Aircraft Design Certification GmbH Reichensteinstr.48 69151 Neckargemünd		Engine mass ballast	Doc-Nr: ADxC-73-SB-029 Issue: B Date: 17.10.2023 Change Nr.: ADxC-73-DC-105
Service Bulletin Bristell B23

Issue	Reason	Date
A	First Issue	09.02.2023
B	removal of inspection option, SB classification changed to "Alert"	17.10.2023

<p>Engine mass ballast</p> <p>Removal or Change of ballast attached to engine</p> <p><i>Note: this service bulleting also replaces ADxC-73-SB-020.A</i></p>
--

Figure 1 Installation drawing (showing Ballast 71B200201 Issue E. The reworked Issue D has straps instead of patches

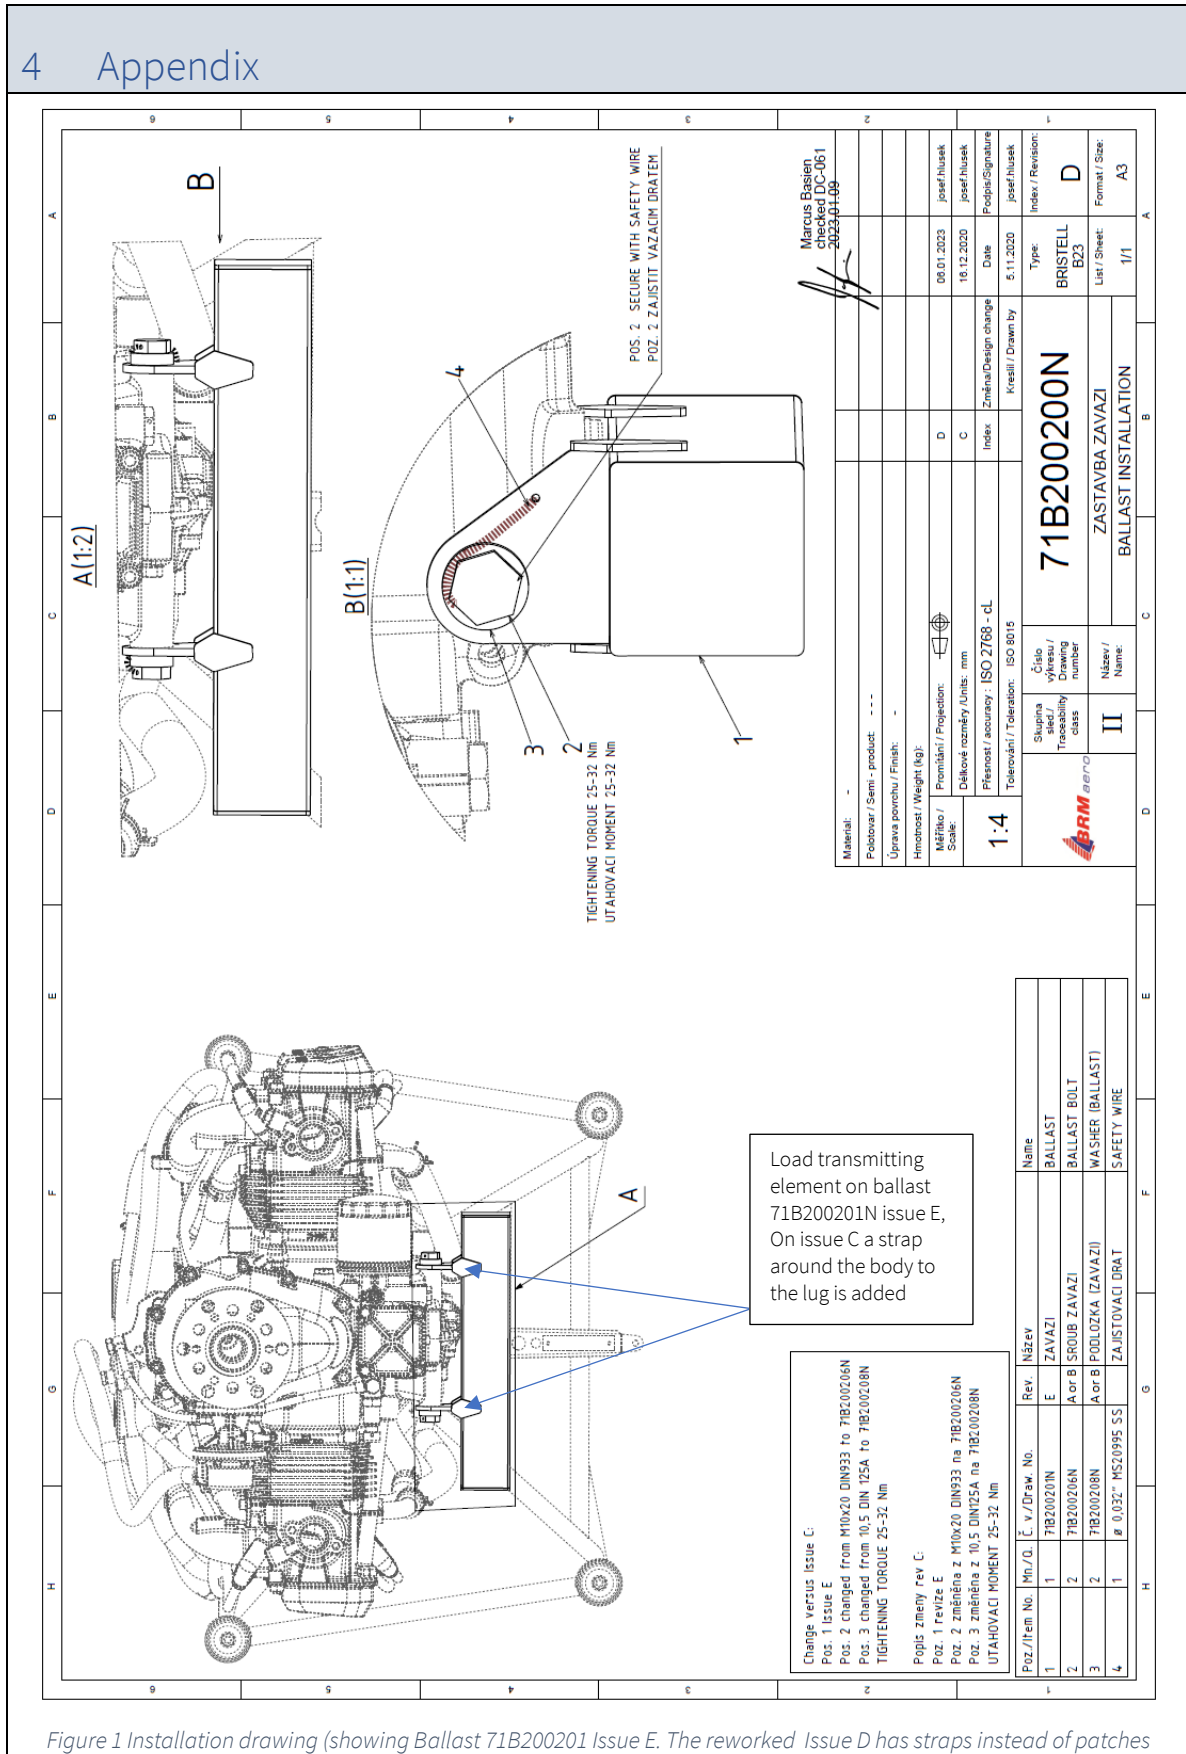
- Remove engine cowling
- If ballast 71B200201N issue B or C is installed, remove ballast.
 - *Acceptable ballast issue D (reworked) or E (factory new) can be identified by presence of load transmitting elements between lug eye and body (ref. Figure 1), Issue D (reworked) has straps all around the ballast body, Issue E (factory new) has lug patches.*
 - *Not acceptable Issue B or C do not feature this (ref. Figure 4)*
- Reinstall cowling.

- Remove engine cowling
- If ballast 71B200201N issue B or C is installed, remove ballast.
- Before installation of new ballast 71B200201N issue E:
 - check 71B200206N issue B Ballast bolt for unthreaded shaft length of 6 mm
 - check 71B200208N issue B washer for thickness of 3 mm
- Install factory new 71B200201N issue E Ballast using bolts PN 71B200206N issue B and 71B200208N issue B washer (2ea) according to installation drawing 71B200200N issue D; Torque attachment bolts to 26-32 Nm
- Perform engine run up according AFM, perform minimum 5 rapid RPM changes idle to max RPM. Shut down aircraft according AFM.
- Recheck torque of bolts PN 71B200206N issue B after cool down.
- Apply safety wire.
- Reinstall cowling.

71B200200N issue D	Ballast Installation
71B200201N issue D (OR E**)	Ballast
71B200206N issue A (OR B*)	Ballast Bolt (2ea)
71B200208N issue A (OR B*)	Washer (2ea)

Figure 2 Cracks found on ballast lug

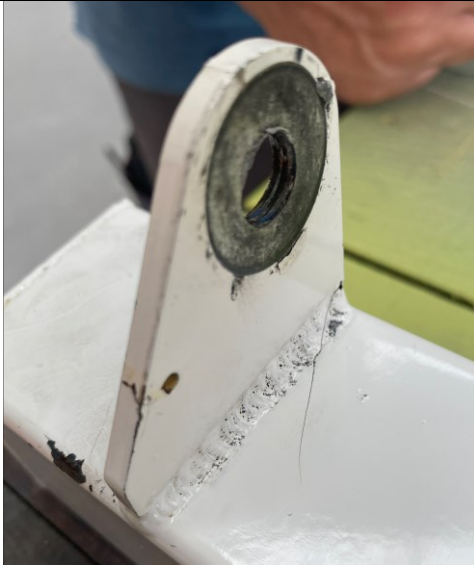
Insufficient or loss of attachment bolt torque can lead to excessive wear on attachment bolt shaft and cracks of attachment lugs due to resulting pounding vibration. This, if undetected over long period of time, could lead to partial or total loss of attachment. On one occurrence this did lead to inflight loss of the engine ballast mass. Refer to visualization in section 4.
